Access Compliance Report

Public Rights-of-Way

(Pedestrian Signals)

Intersection ID: N/A	Main Street:	Cross Street: N/A	Location: N/A
ADA ID: 25F839D1EF7F	Signal Type: One Push Button-Non APS	Overall Compliance: No	Severity Score: BTN 1: N/A BTN 2: N/A No BTN: N/A
Codes/Mitigation Info/Possible Solution		Field Measurements/Component Compliance

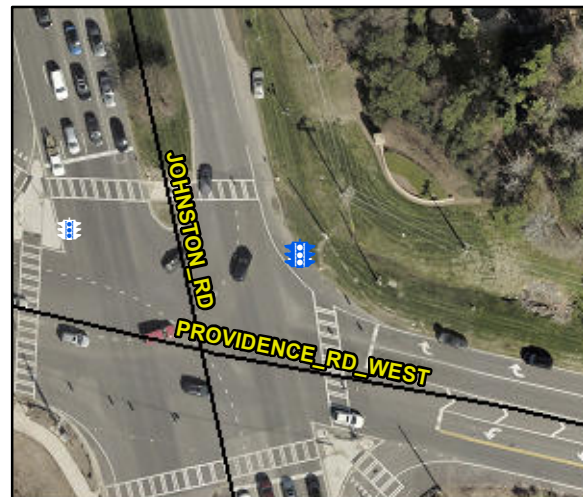
Surveyor Notes: NO CURB

PROW/ADA: TMUTCD 4e.08, R404.3, R406.2, R404.7.3

Possible Solutions: Replace Signal Push Button With APS Button on New Post. Remove & Relocate Sign.
